No. EL/3.1.35/2 Electrical

MODIFICATION SHEET NO. RDSO/2013/EL/MS/0427 (Rev.0), Dated 23.10.13

ModificationSheet for MCP control circuit in three phase electric locomotives.

Annexure-I

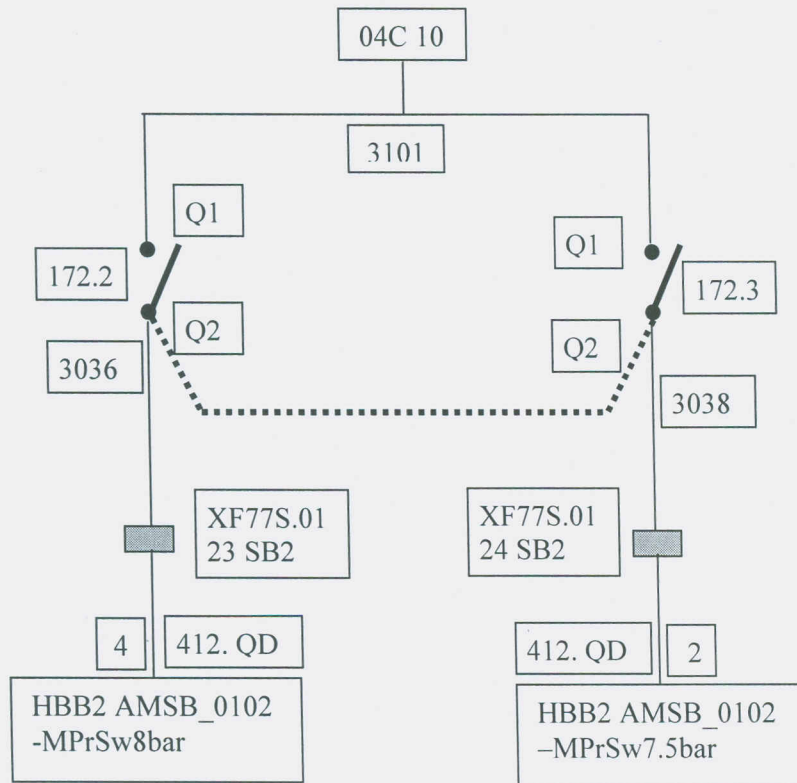
As per existing arrangement, both pressure switches i.e. MCP-1 & 2 are connected to 110 VDC. One pressure switch (Sch.Pos. 172.2) is set at < 8 kg/cm² and other pressure switch (Sch.Pos. 172.3) is set at < 7.5 kg/cm². The feedback to pressure switches are received by cable no. 3101 by both the pressure switches and output is through cable no. 3036 and 3038 respectively as shown in the existing circuit (Annexure-I).

To overcome the problem, the existing arrangement should be modified by setting both pressure switches to 10 to 8 kg/cm² and providing parallel path between two switches. Parallel path shall be provided by giving a loop between cable no. 3036 and 3038 as shown in the modified circuit (Annexure-I).

1. Both Pressure switch shall be set at 8-10kg/cm².
2. Loop shall be provided between wire no. 3036 and 3038.
